***Interactive comment on* “Linking groundwater travel times to stream chemistry, isotopic composition and catchment characteristics” by Elin Jutebring Sterte et al.**

Introduction comment from reviewer #2 In the manuscript "Linking groundwater travel times to stream chemistry, isotopic composition and catchment characteristics," Sterte et al. analyze the drivers of catchment travel times across catchments in norther Sweden. They use a physical hydrology model combined with particle tracking to generate transit time distributions and compare this to isotopic and stream chemistry observations. Overall, I think that the study is well done and the manuscript is well written and easy to follow.

Fig. 1. The Krycklan catchment

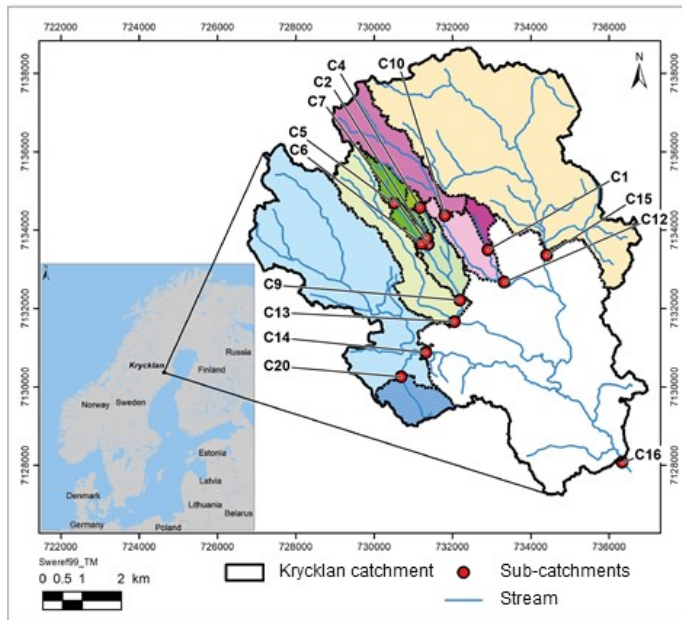
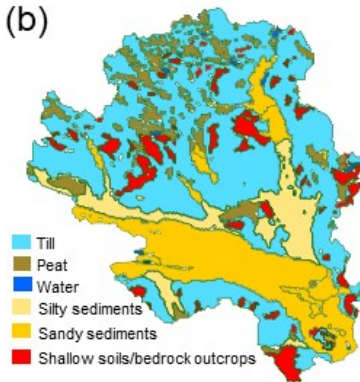
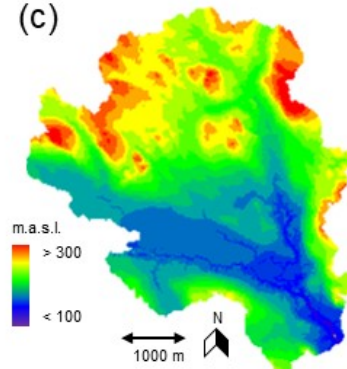
I think the catchment numbering could be done in a more intuitive way so its easier to separate unique outlets (i.e C12-15). I would suggest giving each of these outlets their own letter and then numbering points within them potentially by drainage area, that way its easier to compare when points are within the same drainage or not.

- Authors response: We understand the concern regarding this comment. However, we hesitate to change the names of the sub-catchment since they all have been included in many previous peer-reviewed papers, which argues against introducing new names in this manuscript. It would make all comparisons with previous papers from the Krycklan catchment unnecessarily difficult and confusing. We hoped that the colors of figure 1 will help to distinguish which sub-catchments were connected. However, we will also add a color code in table 1, which will further connect the different sub-catchments in figure and text.

Fig. 2. Model setup

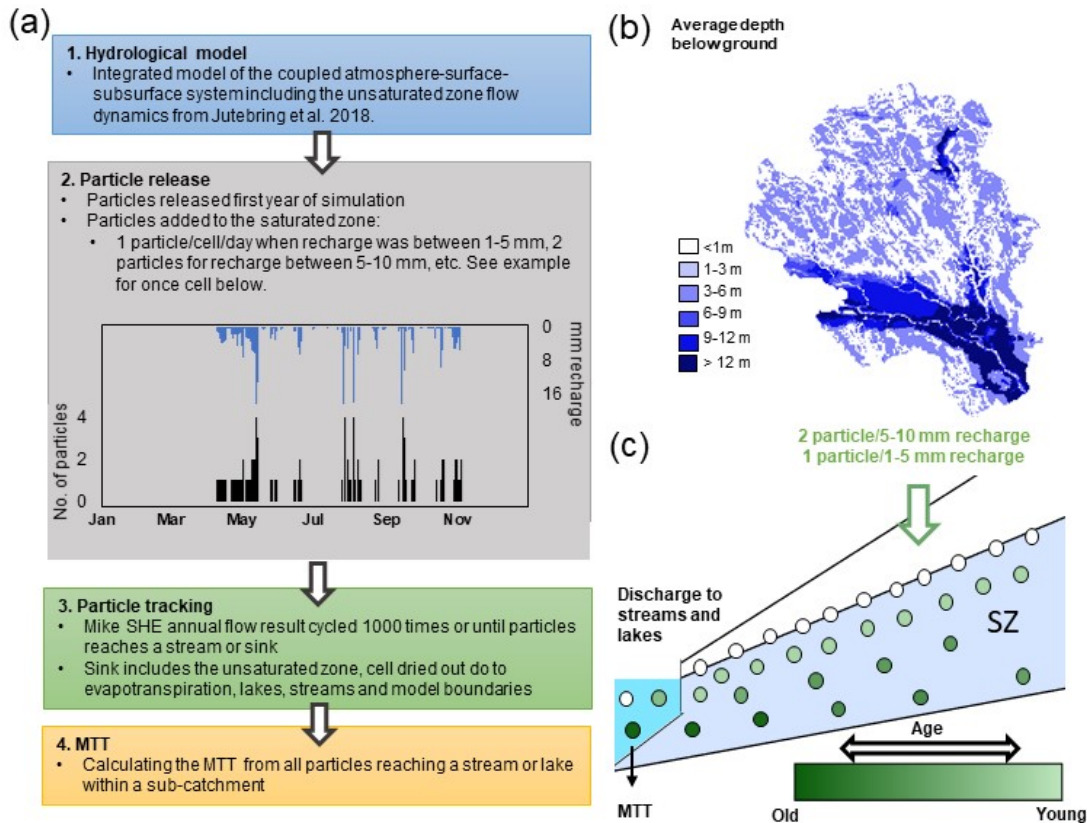
For the most part I think the paper is very clearly written, however the description of the modeling approach is a bit confusing and could use some more details. For example the term simulation is used to refer to both the hydrology model and the particle tracking portion which can be confusing. This section could be helped by a figure or a schematic to illustrate the approach I think.

Line 138-140: This is confusing are you trying to say that the hydrologic model is run first and then the particle tracking is applied to the outputs of that model?

- Authors response: Reviewer #1 also requested a schematic figure, and we agree with the reviewers and like the suggestion to better describe the modeling procedure, see a preliminary figure 2. We will also give more distinctive terms to the hydrology modelling part and the particle tracking part of the manuscript. One reason for the confusion is probably that much of the hydrological model was described in a previous paper. Although this paper was cited, we realize that we need to explain the model setup in more detail also in this manuscript so that potential readers can grasp the general idea of what has been done without reading the previous paper.

- Authors response: Yes, the model flow field is run first and, then one year of the flow field is cycled for 1000 years with particle tracking applied to the flow field results. We will add the schematic figure (see figure 2) to clarify these steps and be more direct that the hydrology model output used are the results from the model is used in Jutebring et al. 2018. We will also add a more in-depth description of the water movement model in the revised manuscript.

Fig. 3. Discharge distribution

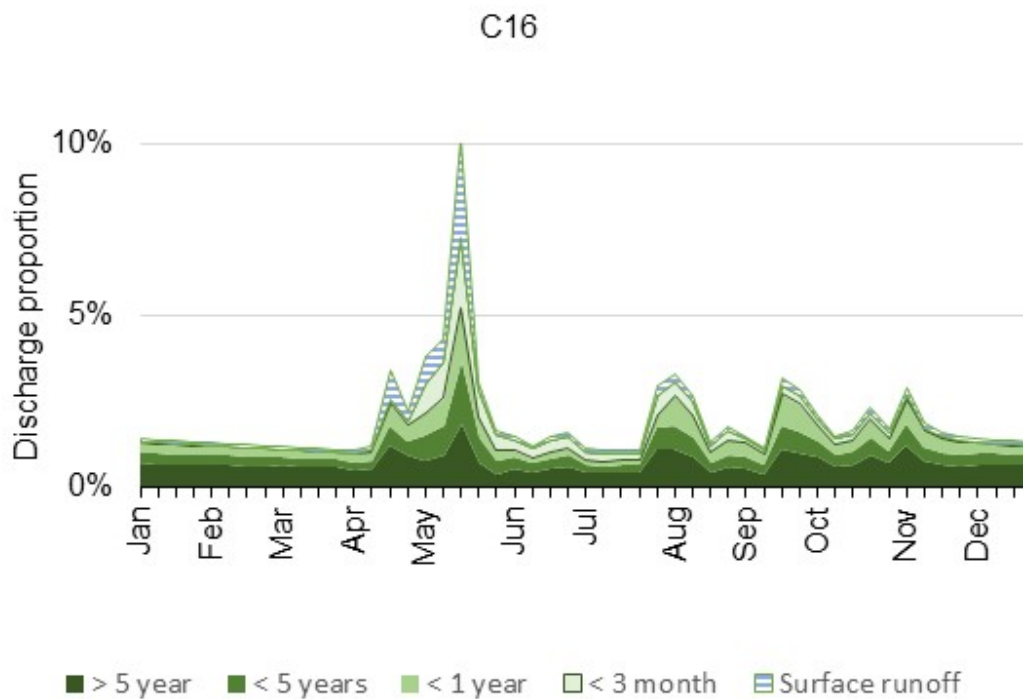
I think some of the tables could be converted to figures to better present the information. For example Table 4 could be presented as a series of maps.

of the information in Table 4 are shown in the figure 2 in the manuscript. We attempted to make maps at the onset of this study, but the information was not clearly visible. However, we will add travel time distribution per month for each sub-catchment to visualize the impact of various fractions of travel times. See an example of C16, Figure 6.
